Village of Itasca

Committee of the Whole Meeting Agenda June 21, 2016

TO: Village President Jeff Pruyn and Itasca Board of Trustees
FROM: Nancy Hill, Community Development Director
DATE: June 16, 2016 for June 21, 2016 Village Board COW Meeting
RE: Relief from Building Code for 400 E. Walnut Street (Itasca County Club)

Subject: Village of Itasca/Illinois Tollway/IDOT/DuPage County/Township of Addison
Intergovernmental Agreement (IGA)
Illinois Route 390 Hamilton Lakes Drive to Arlington Heights Road
Recommendation for Execution of Cost Participation Letter (with conditions)

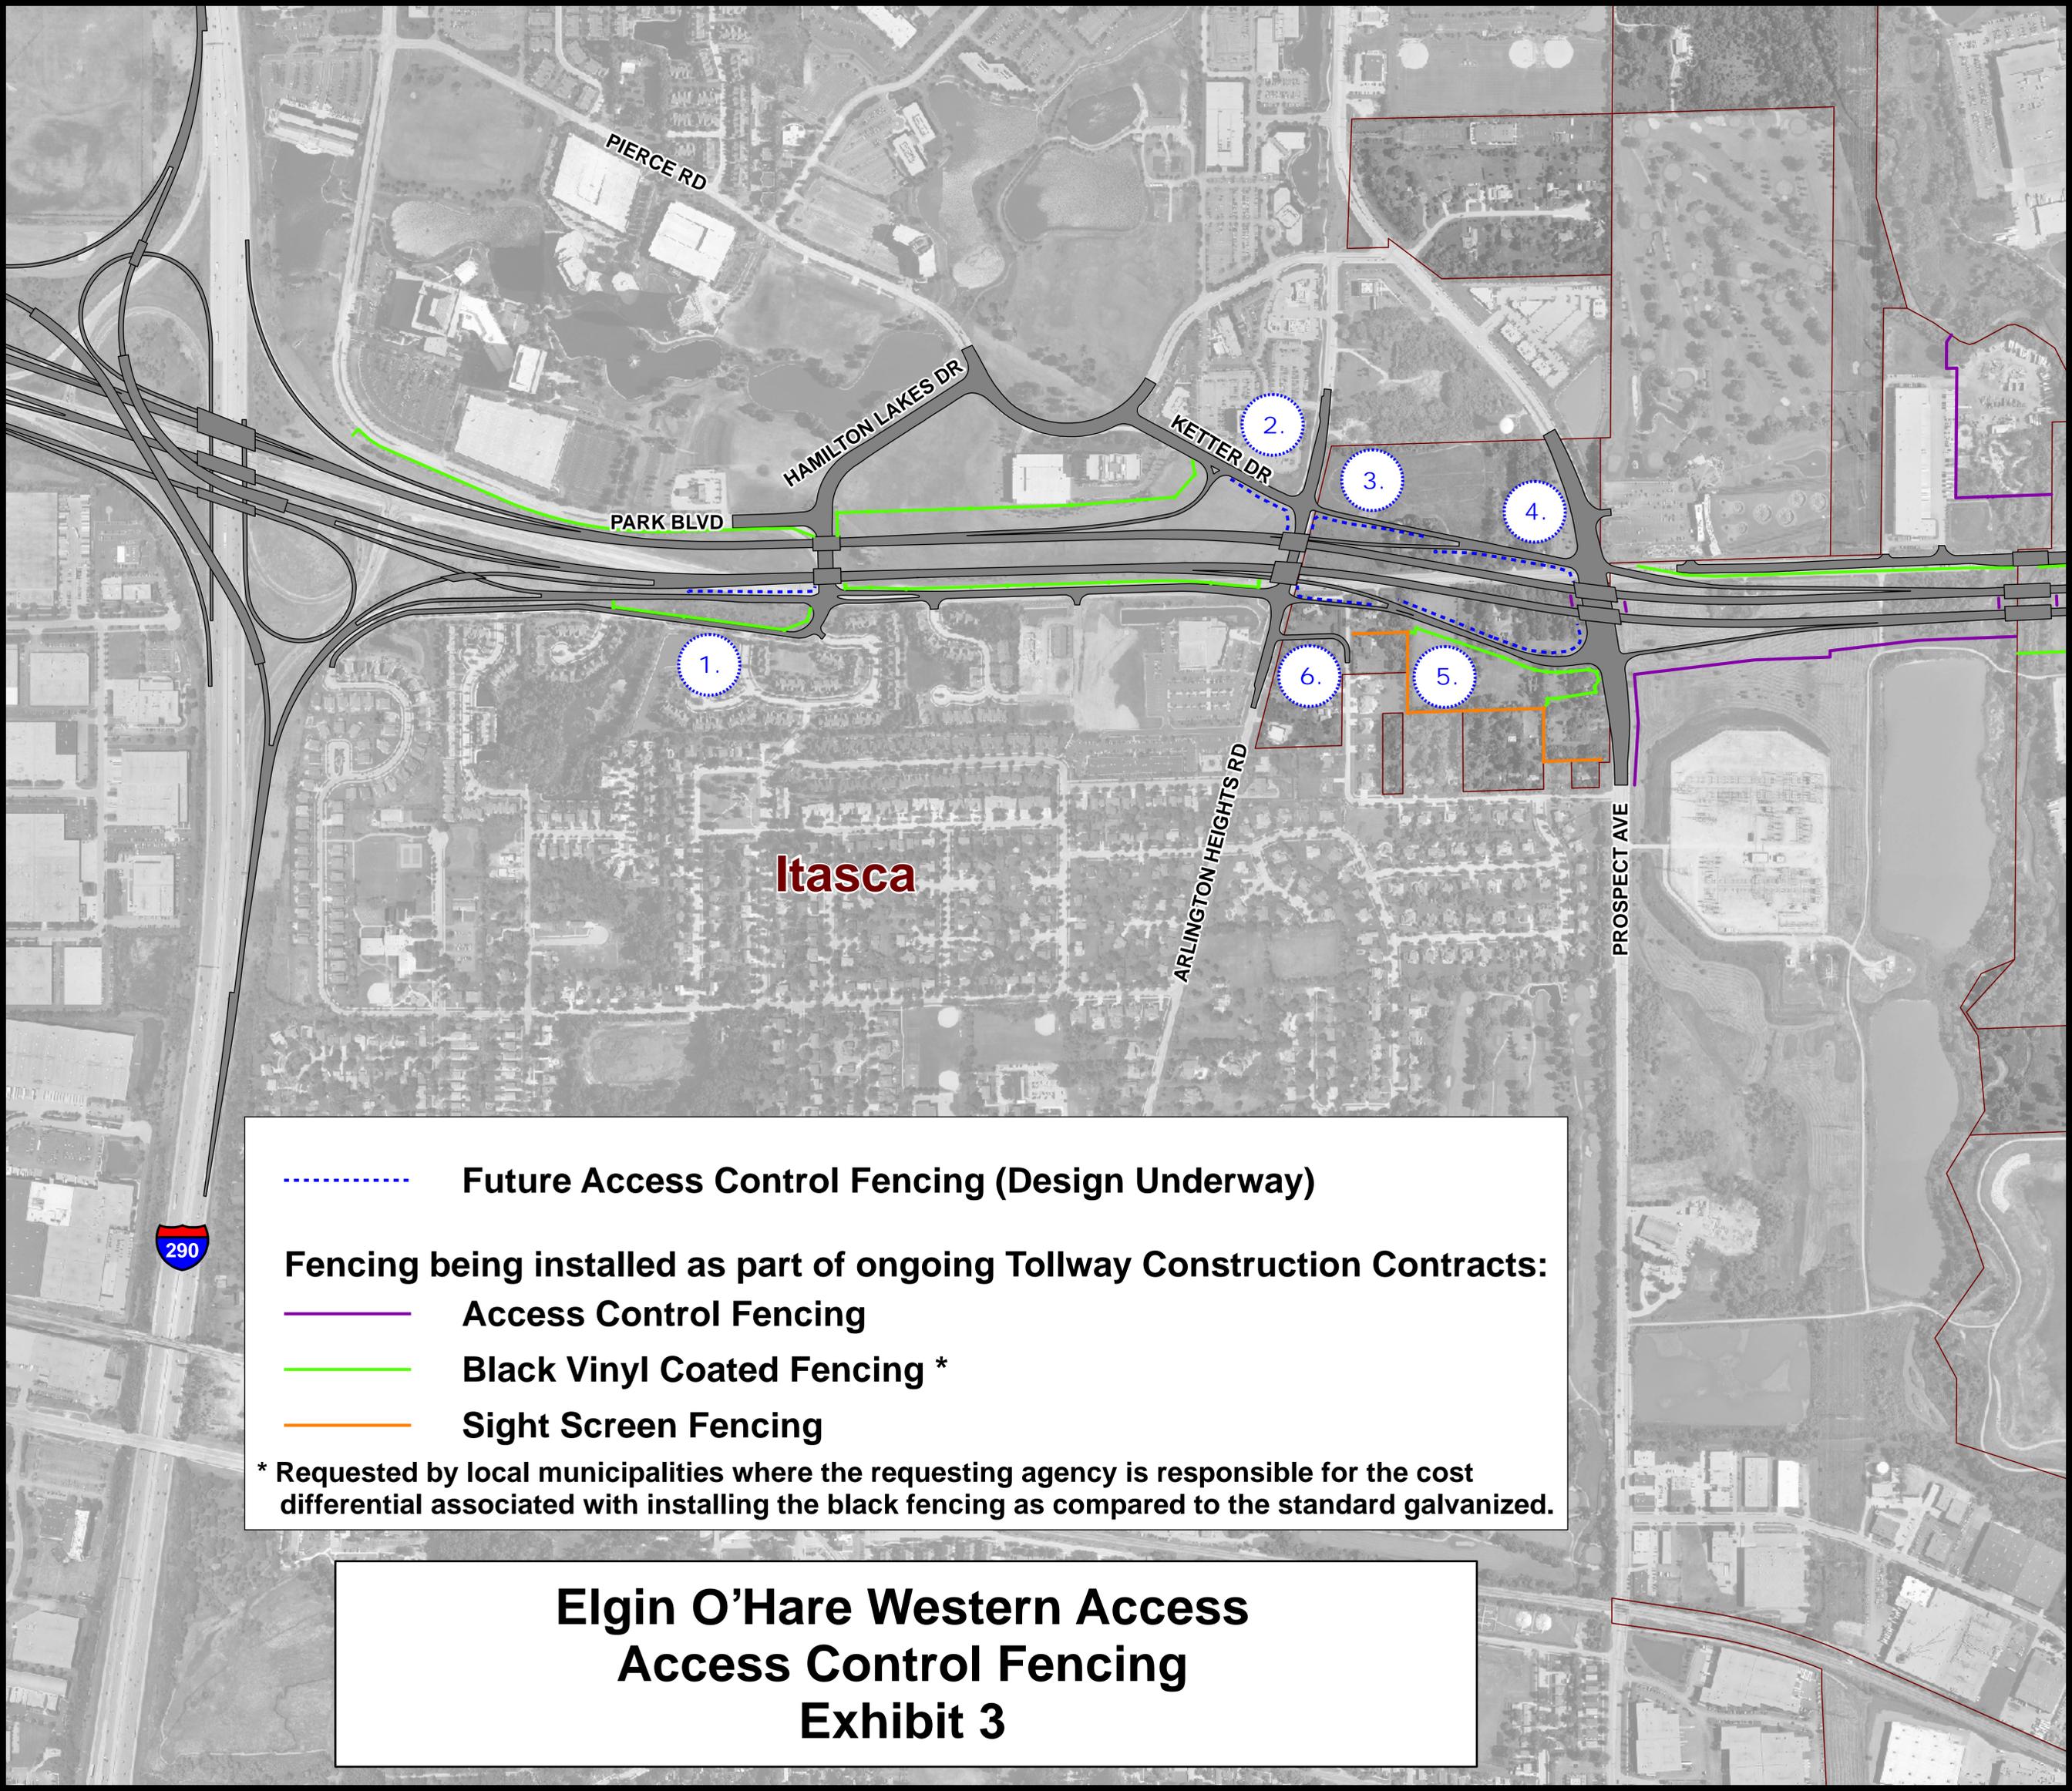
The Tollway recently provided the attached overall access control fencing exhibit, which shows not only access control locations which have been previously approved, but also future locations where access control fencing is proposed to be located. The additional access control fencing construction will be included as part of a future ITS (Intelligent Transportation System) contract. Plans for that ITS contract are currently in the early design stage and have not yet been submitted for review.

The Tollway is requesting direction from the Village regarding their desires for additional enhanced access control fencing, so that this information can be included in the final design plans for the ITS contract currently in the early design stages.

- **I request that the Village Board provide direction as to which specific locations, if any, where upgraded access control fencing is desired. I will convey those directions to the Tollway design engineers and the design engineering plans will then be reviewed accordingly. If there are any significant differences from the location shown when the design plans are submitted, that information will be brought back to the Village Board for discussion.**
